MEMORANDUM

DATE: 30 June 2020

RE: North Sydney Olympic Pool redevelopment – DA 347/19 – 4 Alfred Street Milson Point – Comments on Recommended Conditions for Development Consent - DA conditions

Figure 1. Architectural Plans Ao12 – Rev U – Level 1 Plan showing location of access ramp.

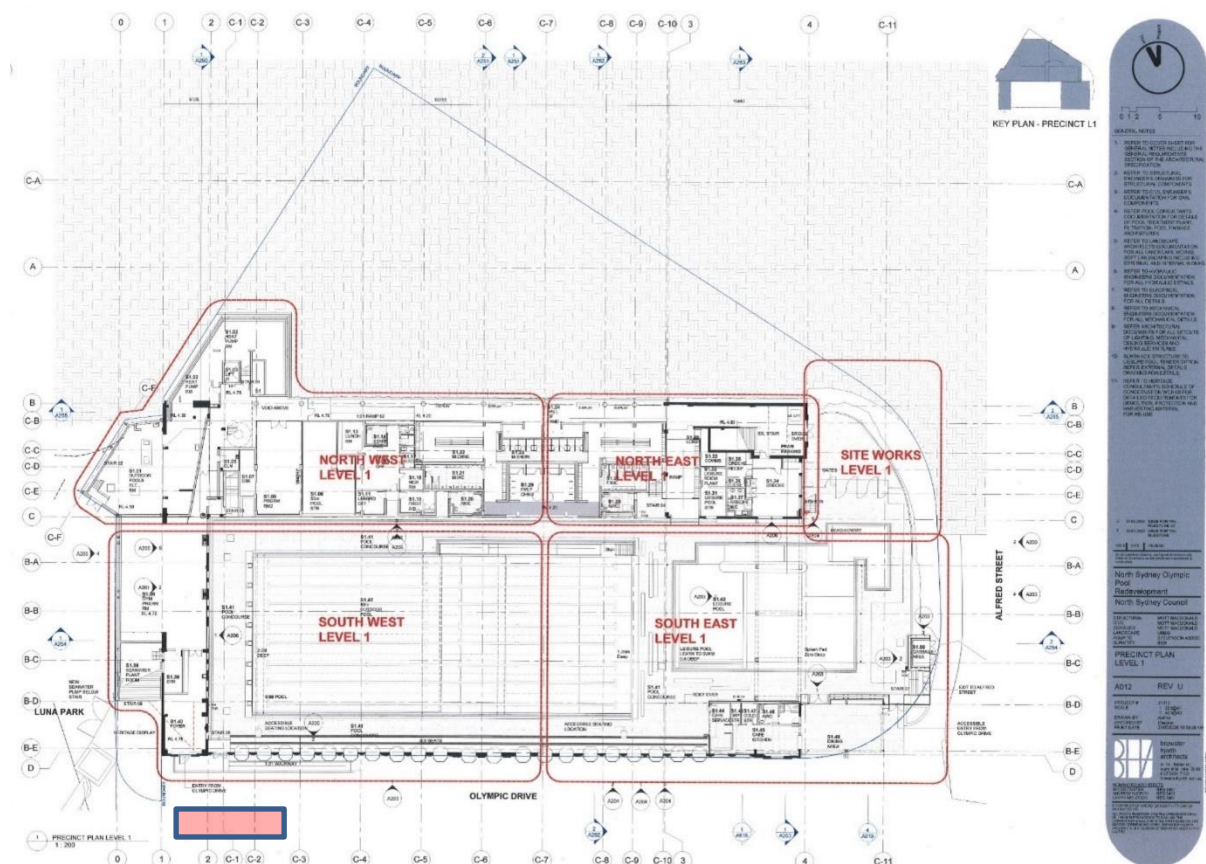
A review of the design was undertaken by Councils Access & Inclusion Co-ordinator before the Development Application was lodged in October 2019 and it was recommended that ramp access be provided for in this location. The ramp has been designed in this location to specifically cater for the needs of people in wheelchairs and or who have mobility issues and are arriving to the pool by ferry (Milsons Point Ferry Wharf). The ramp provides access to the new Gym / Program room located on Level 1. (Refer to figure 1 - Architectural Plans Ao12 – Rev U – Level 1).

If the ramp is removed or modified so that it no longer meets DDA or BCA standards, these facility users would have to make their way up to another on grade entry located adjacent to the level 1 café and then back to the gym and program room on level 1 which is a round trip of over 150m. Alternatively these users would have to make their way to the main entrance to the pool on Alfred

The ramp in this location is also required for egress of the south western side of the facility (Level 1) to satisfy the requirements of the BCA.

The proposed pedestrian access ramp on Olympic Drive is to be amended so that the profile at the end of the ramp is angled (Chamfered) at 45 degrees so that it falls within the wheel envelope of a 19m semi-trailer and does not impede access into and out of the gates to Luna Park adjacent to the western end of the pool concourse.

Figure 2 North Sydney Olympic Pool lot ownership diagram including Lot 127637 – Olympic Drive – owned and controlled by Council. (Red Hatch area)

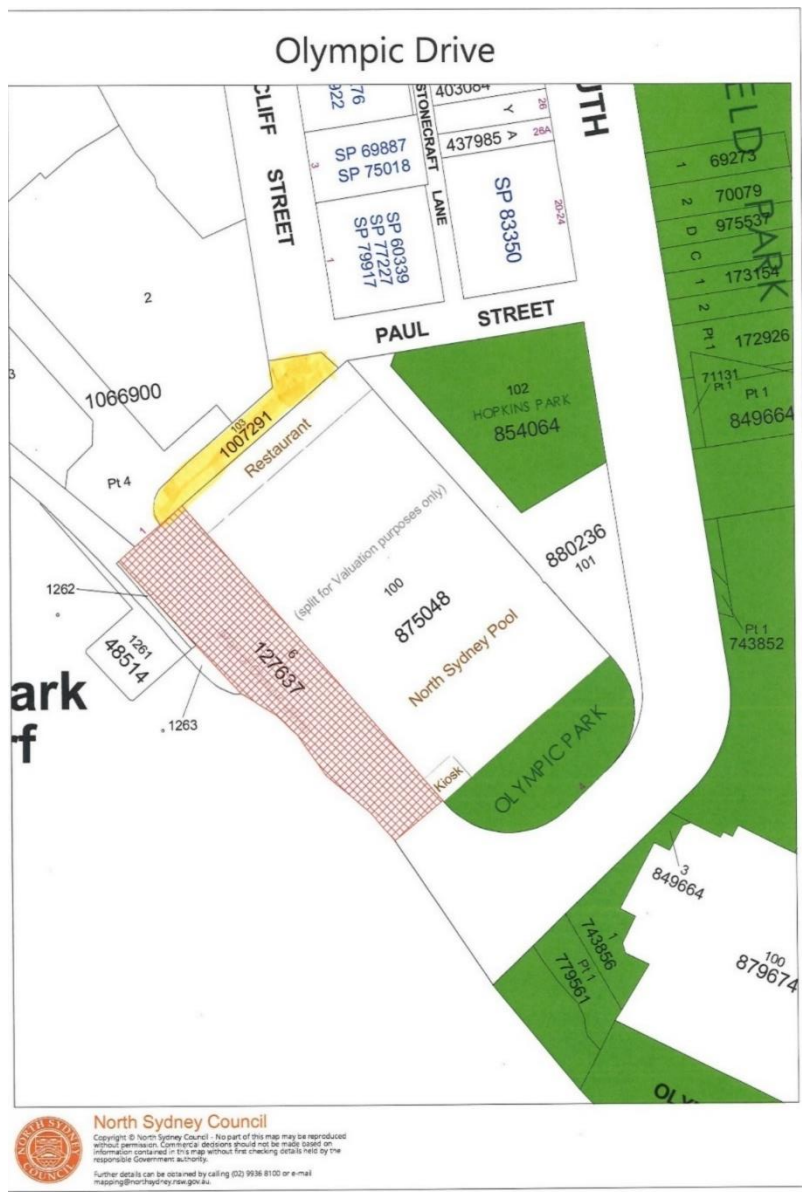
The applicant has also sort advice from North Sydney Councils Property Department which confirms that the ramp in question is simply an extension of an existing ramp which is located in the public roadway (lot 127637) known as Olympic Drive which is land owned and controlled by Council.

Refer to Figure 2 which identifies Lot 127637 (Marked in Red- hatch)

Figure 3 Current Truck turning plan Heavy Rigid Vehicle – HRV – access to Luna Park Loading Area – over Council land.

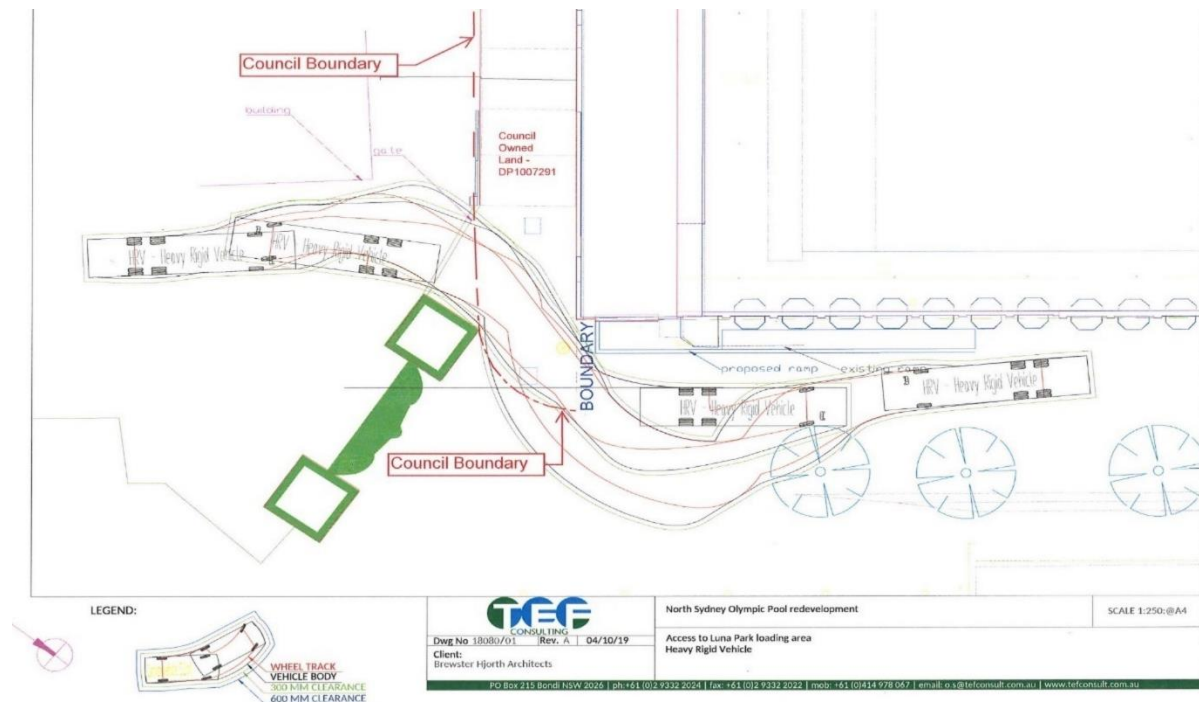
As can be seen on the truck turning plan prepared by Traffic Engineering Consultants TEF - Figure 3 – Luna Park requires access over Councils land to gain access to the service gates which are located between the western access stairs and the eastern pylon to the Luna Park face. These gates are used for services deliveries and Emergency Vehicle Access.

As can also be seen from the swept path analysis below - the inclusion of an access ramp in this location does not impede current vehicle access for Luna Park. Existing access is maintained for both deliveries and emergency vehicles. Also refer to Figure 4 - Lot Plan

2. The ramp does not impede current access requirements for Luna Park (Large Vehicle including a 19m semi-trailer) as demonstrated in the swept path analysis prepared by TEF – Traffic Engineers. Also the end of the ramp (Landing) is proposed to be now modified – chamfered at 45 degrees to allow for a 19m semi-trailer – “wheel envelope” as shown in figure 3b – marked up drawings that were prepared by JMT Consulting on behalf of Luna Park. Refer to Figure 3b.

Figure 3a Current Truck turning plan “Bronto” Scania P124 Vehicle with a 44m ladder - access to Luna Park – over Council land.

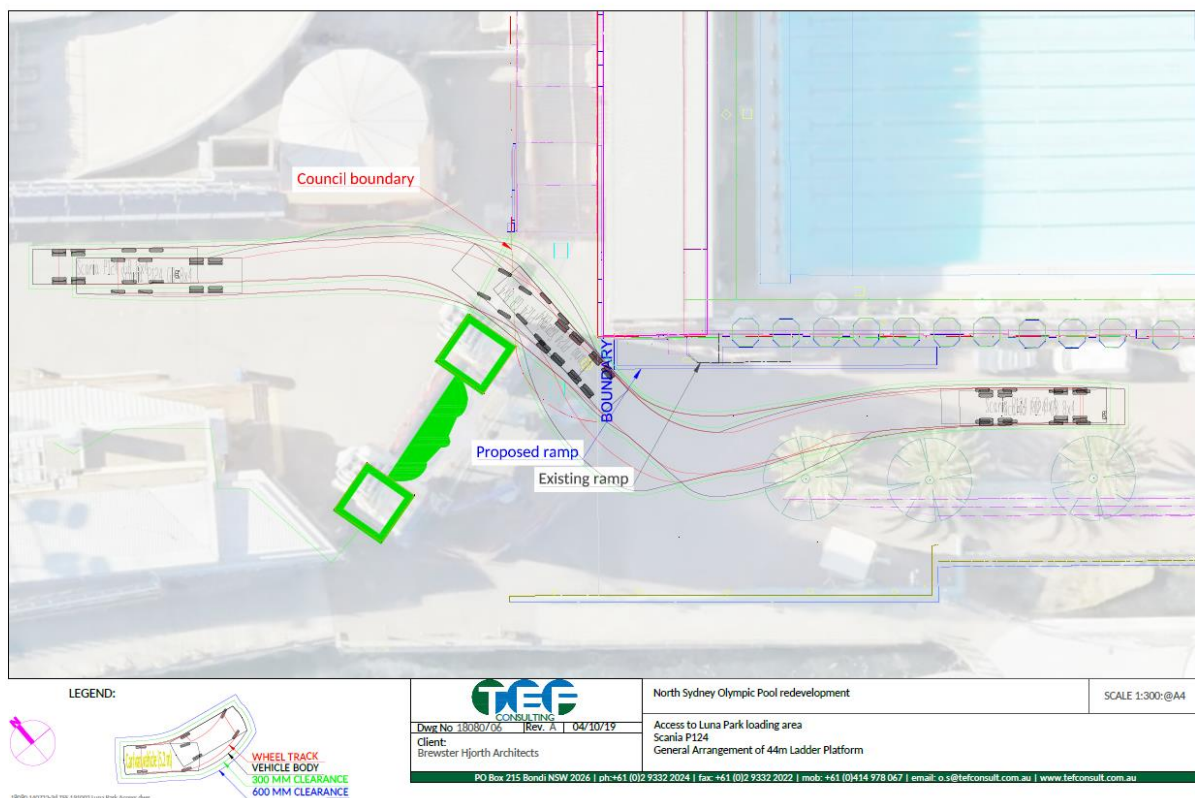
Council has received confirmation from the Metro East 2 - Emergency Services Commander that the emergency vehicle access required for Luna Park is for a vehicle that is equivalent to a 37m “Bronto” 37HDT – equivalent to a Scania P124 vehicle with a 44m ladder. Refer to photo and specifications below.

Figure 4 Lot ownership plan – lot DP 1007291 is land owned and controlled by Council. This Council land is currently utilised by Luna Park for truck deliveries and access to the services gates located at the base of the western stairs.

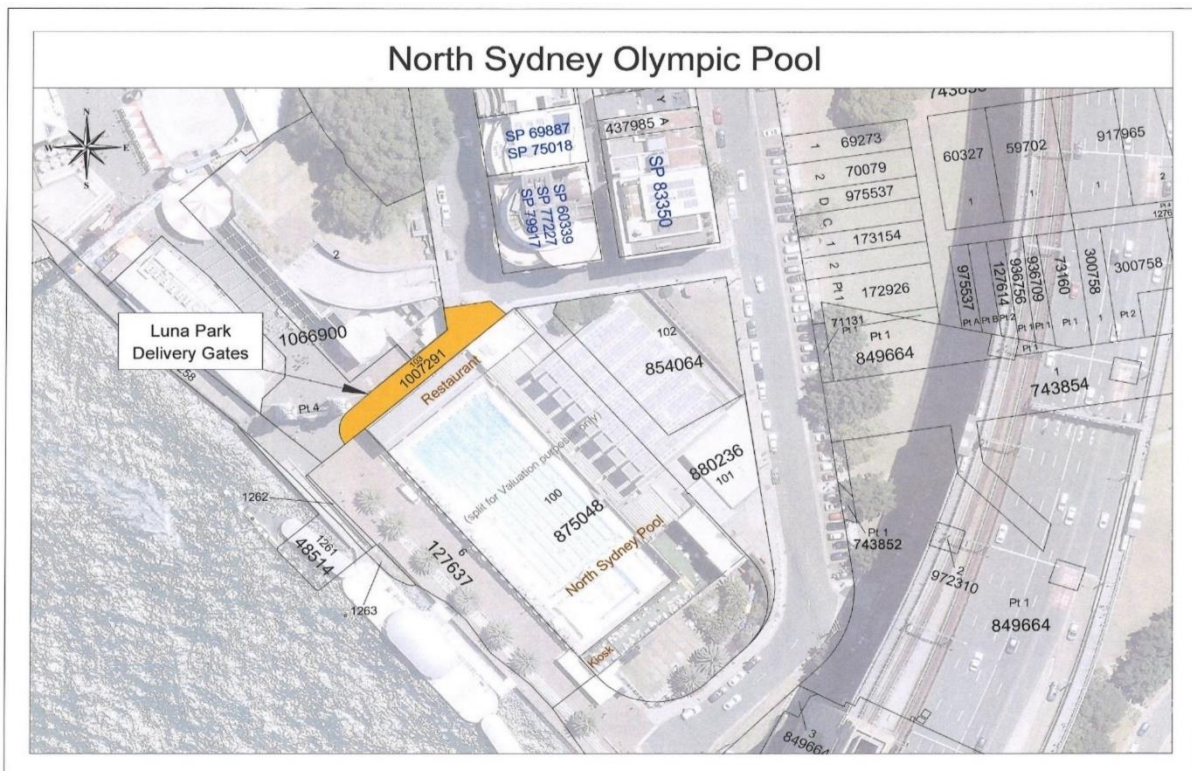
Historically Luna Park has utilised Councils land on the South West Corner of the pool site (Lot 1007291) to traverse trucks and other vehicles across Council land and into their site for deliveries and emergency vehicles access. Councils records show (Gazettal Notice) that the closure of Lot 103 in DP 1007291 was gazetted on 10 December 1999 and remains vested in Council as operational land. When Lot 103 in DP 1007291 was a public road Luna Park was entitled to use the road for access and egress. Upon closure of the road in 1999 the right of Luna Park to use this lot as an access point into and out of the site was extinguished. The certificate of title for lot 103 does not identify any right of way or other easement for access over lot 103 that benefits the land comprising Luna Park. Strictly speaking in legal terms, persons crossing Lot 103 without Councils permission are trespassing.

Figure 5 Photos of the Luna Park gates for deliveries and the route that is currently utilised by Luna Park for site deliveries over Councils land (Lot DP 1007291).

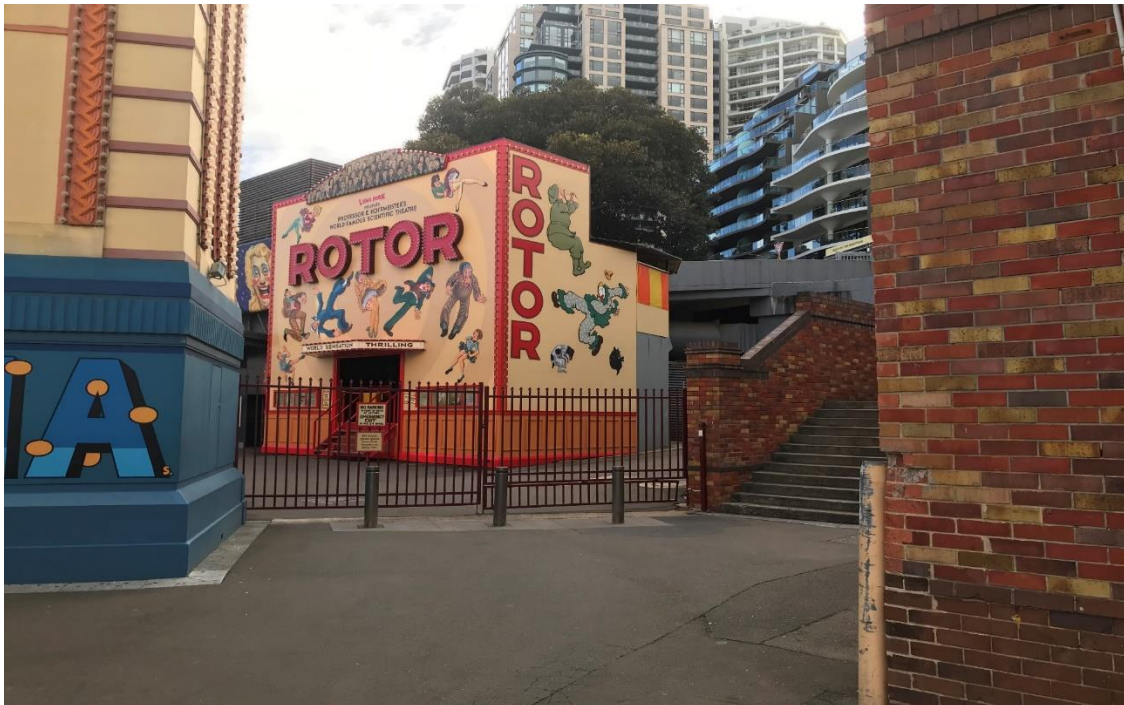
Refer to figure 5 – Site photo of the access gates and the Council owned (Operational land) in question that Luna Park currently uses for site deliveries. The gates that are currently used for deliveries into the Luna Park site are approximately 6750mm wide and have been in operation for over 15 years.

Figure 6. 300 Tonne Crane Swept Path Analysis – This swept path analysis demonstrates it is not physically possible to get a crane of this size to pass through this location.

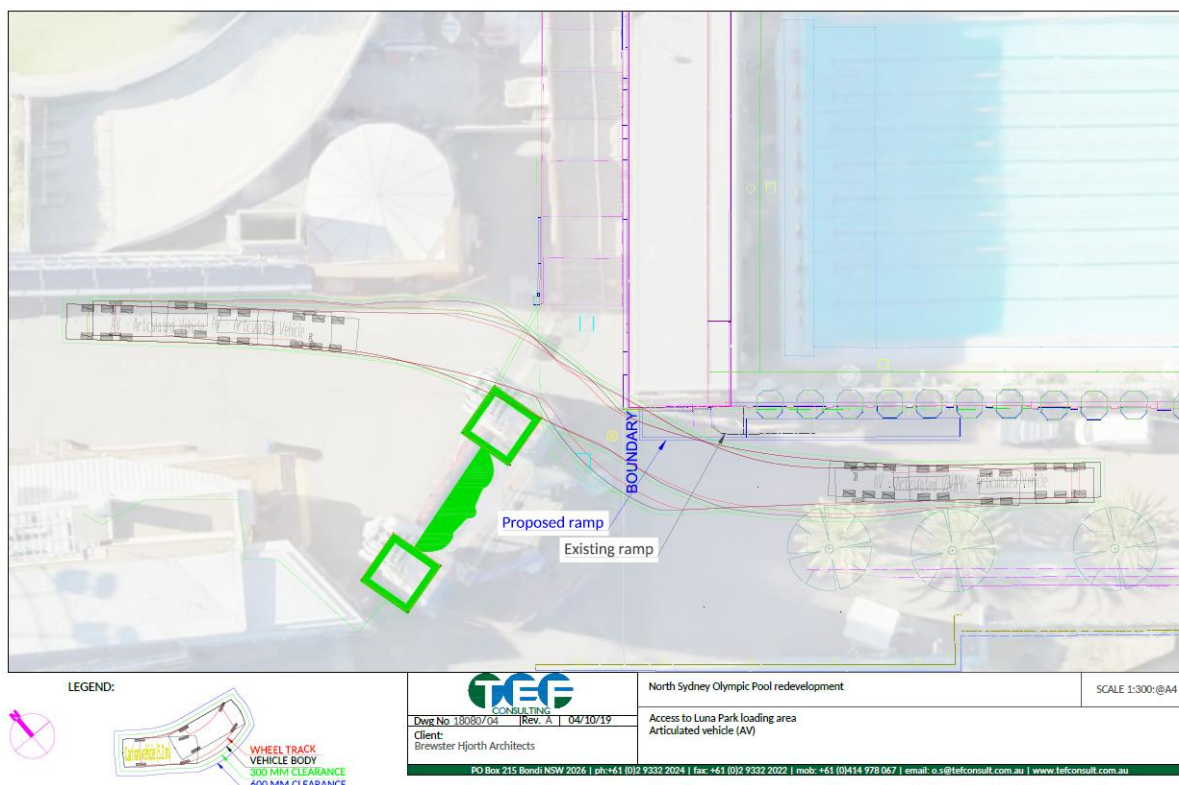
Traffic Engineers TEF have also now prepared a swept path analysis for a 300-tonne crane to see if it can enter the site in this location. As can be seen in the swept path analysis it is not physically possible for a 300-tonne crane fit through these gates. It is not even possible for a 300-tonne crane to fit between the pylon to the Luna Park “Face” and Councils building. Refer to Figure 6

3. The request from Luna Park that Council must enable access through these gates and along Olympic Drive for large semi-trailers and a 300 tonne crane is not physically possible as demonstrated in the swept path analysis prepared by TEF Traffic Engineers Refer to Figure 6.
